**DEV24-05**     **2745 & 2776 N SR9**, Cross Road Engineers, P.C., Agent for KS Real Estate Holdings LLC, requests approval of a Development Plan Approval for a convenience store with gas station in the Commercial North Gateway District (“CN”).

1. **Proposed Development Plans, file dated January 21, 2025**
2. **Color Building Elevations, file dated January 20, 2025**
3. **Development Plan Modification Letters, files dated January 21, 2025**
4. **Replat of Lots 3 & 4, file dated January 24, 2025**

**1 FRONT ELEVATION**  
SCALE: 1/4"=1'-0"  
EAST SIDE OF BUILDING  
TOTAL SIGNAGE AREA = 60 sft

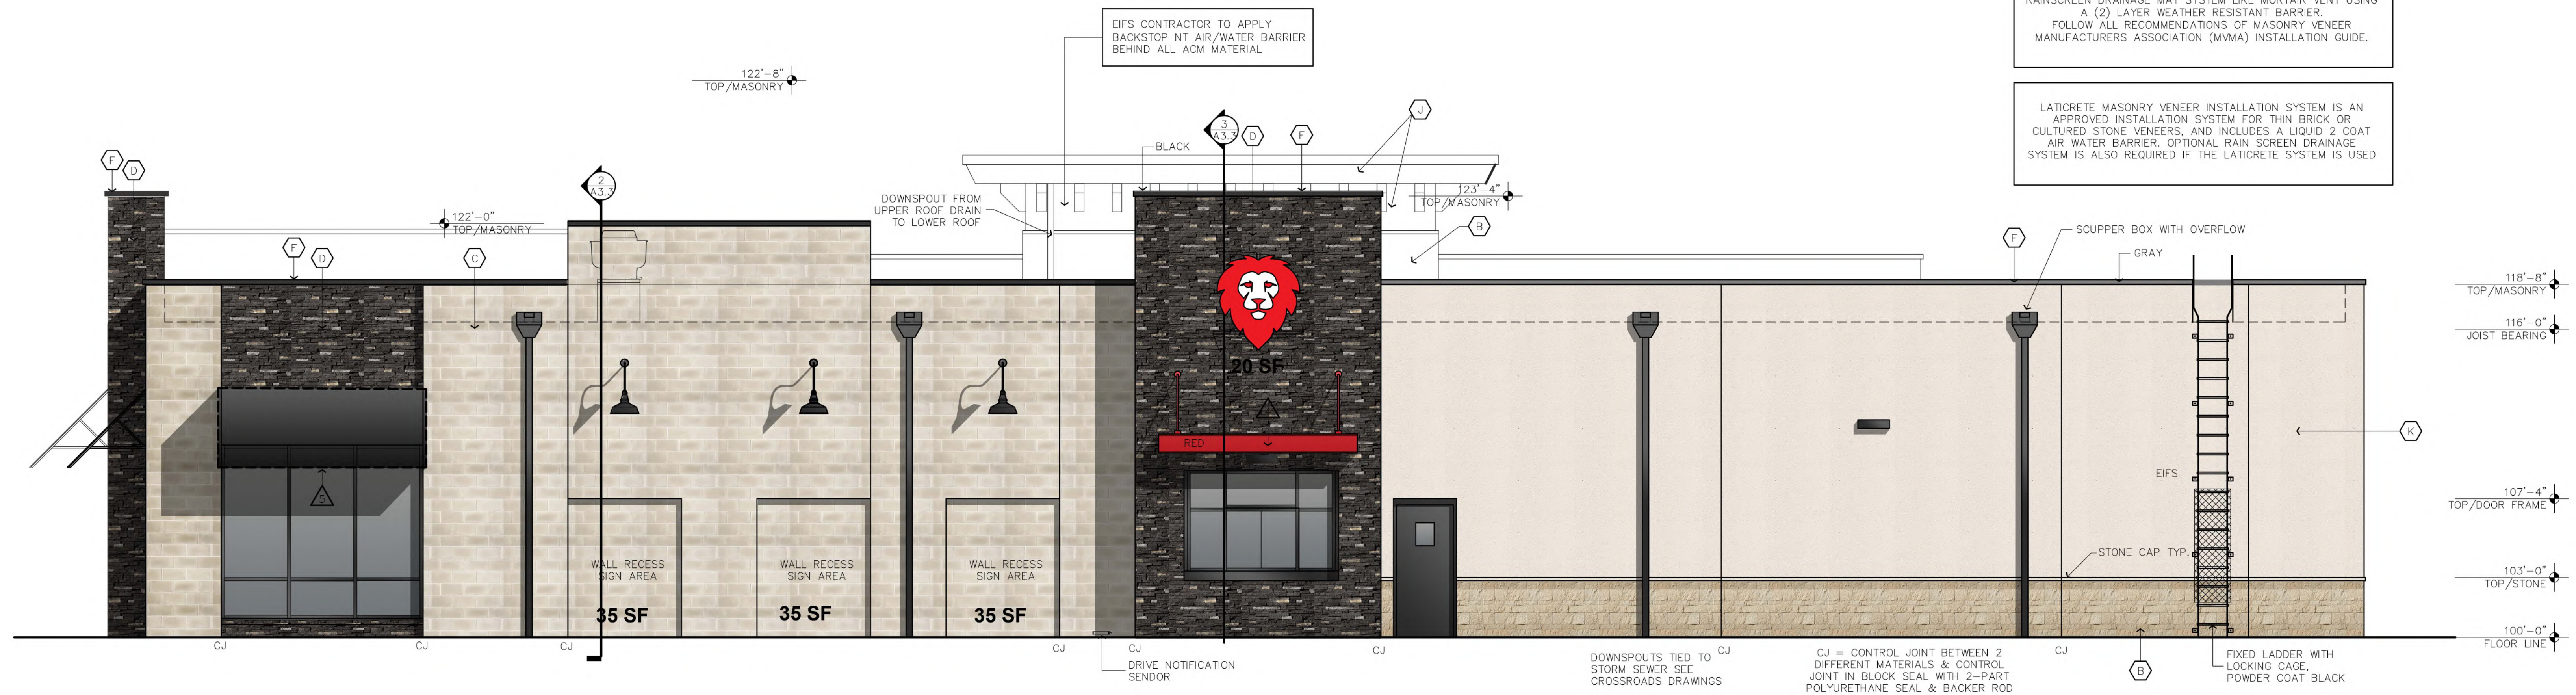
**Findings:** The proposed elevations depict a standard Leo's Eatery and Gas Station facility with brick, FSEI, and metal wall treatments along the primary building, brick and stone treatments for the pillars of the gas station canopy, and a metal roofing for the canopy itself. A brick wainscot has been provided along ½ of the west elevation and almost the entirety of the south elevation walls. All walls are fronted by landscaping in the form of lawns, grass, and / or shrubs. All facades have a mix of material colors and textures to emulate brick and stone. The west elevation, along Eagleston Way, which includes the drive through window, has a large blank

expanse for roughly ½ of the wall. This wall does not meet the UDO's Design Standards for required modulations on a front façade, and as such the Petitioner has filed a Modification Request (detailed below). All other elevations meet the Design Standards of the UDO without need for Modification Requests.

4. Requesting reduction of windows and doors as a percentage of façade on west and east façades.

**Findings:** The UDO requires 45% of a front façade to be windows and/or doors. The east façade is at only 44%, and the difference is not significant enough to notice, as such, staff supports this request. The west façade is at only 15.5%, with only the drive-through window accounting for this requirement. Though this is far below the requirement, the general look of this façade being that of the "rear" of the building, coupled with the aforementioned landscaping and realities of the site, leave Staff willing to support this request for a reduction in UDO requirements of windows and doors as a percentage of the façades on the east and west sides of the building.

**2 REAR ELEVATION**  
SCALE: 1/4"=1'-0"  
WEST SIDE OF BUILDING  
TOTAL SIGNAGE AREA = 125 sft

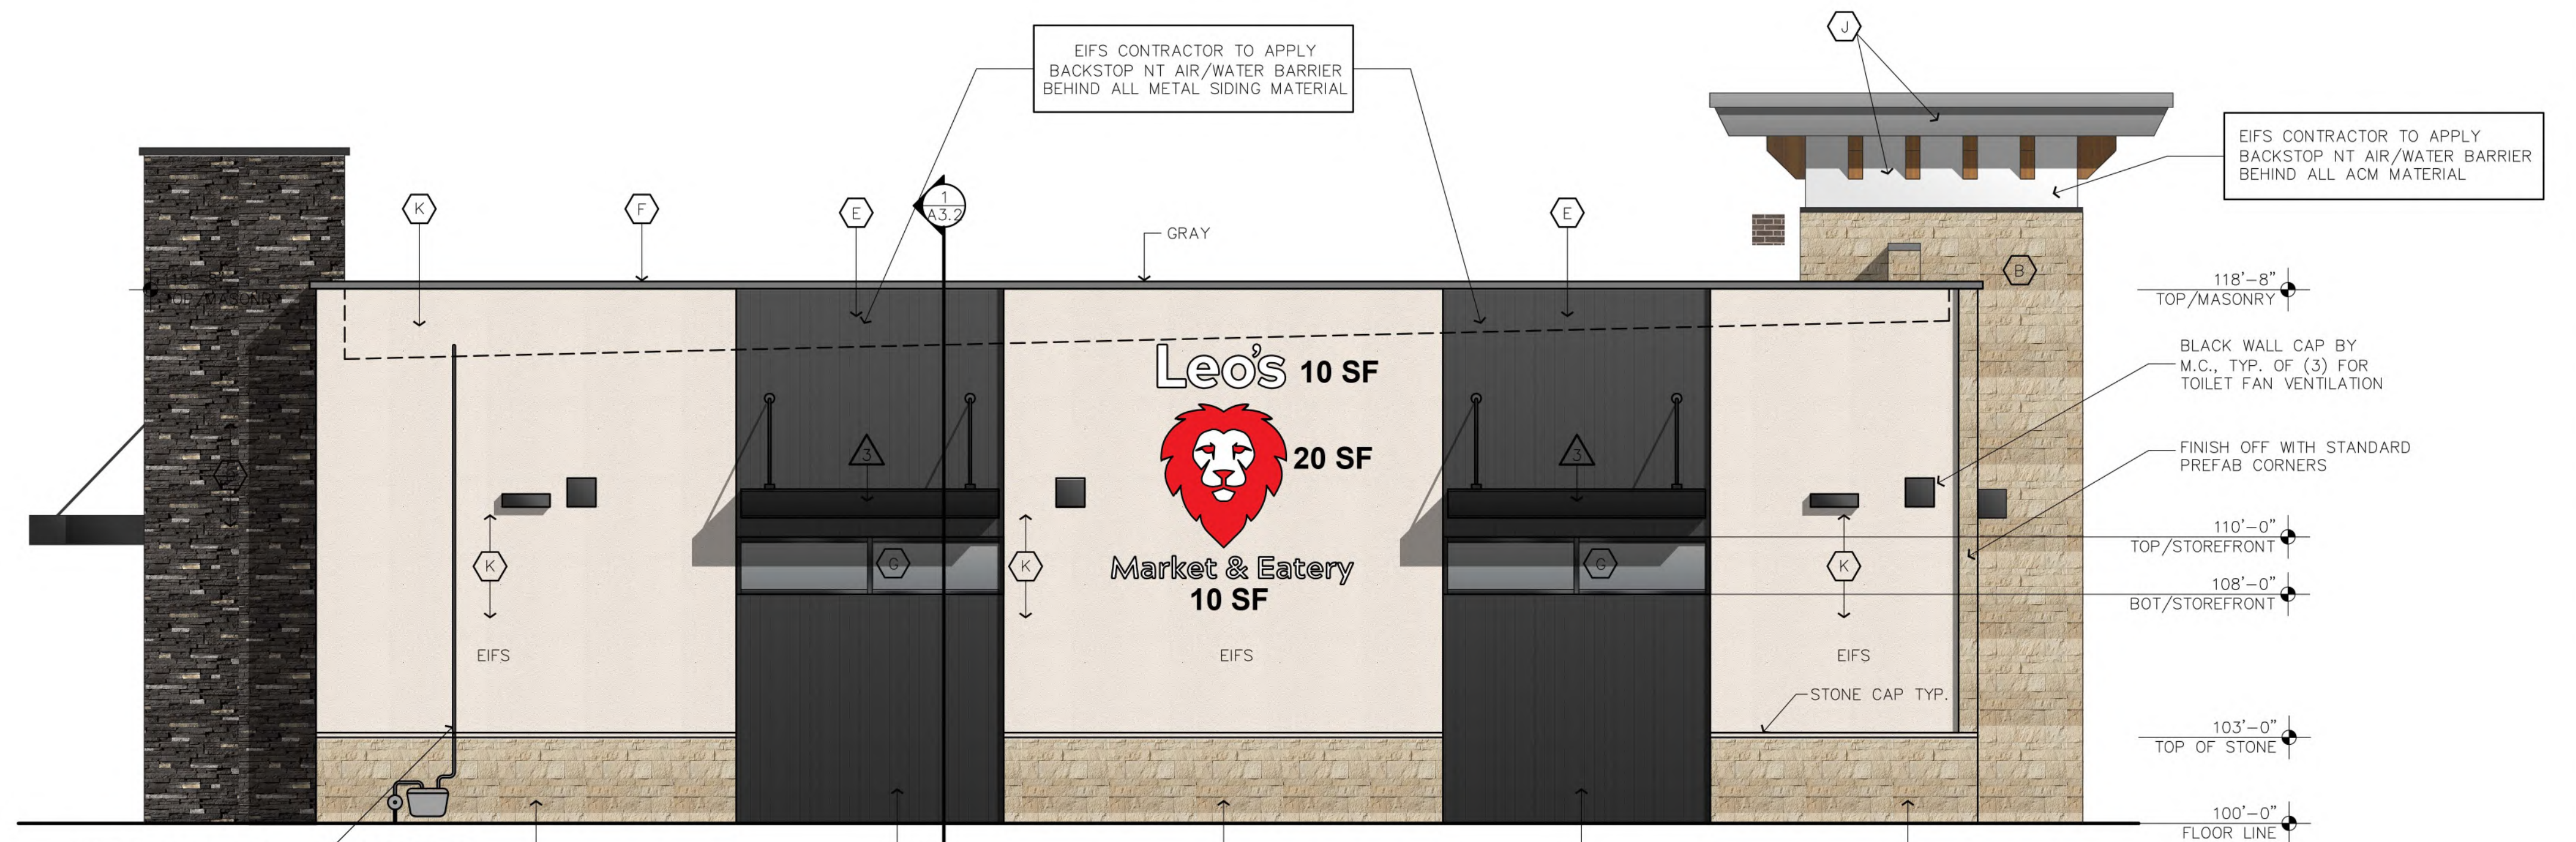
3. Requesting reduction of façade modulation requirements along the west façade.

**Findings:** The UDO requires façade modulations every 40' on a Front Façade. The southern portion of the west façade after the drive-through window does not meet this requirement. Staff finds that the provide architectural styling throughout the rest of the building coupled with the foundation landscaping along this portion of the building provide sufficient enhancements to the façade to allow for this modification request.
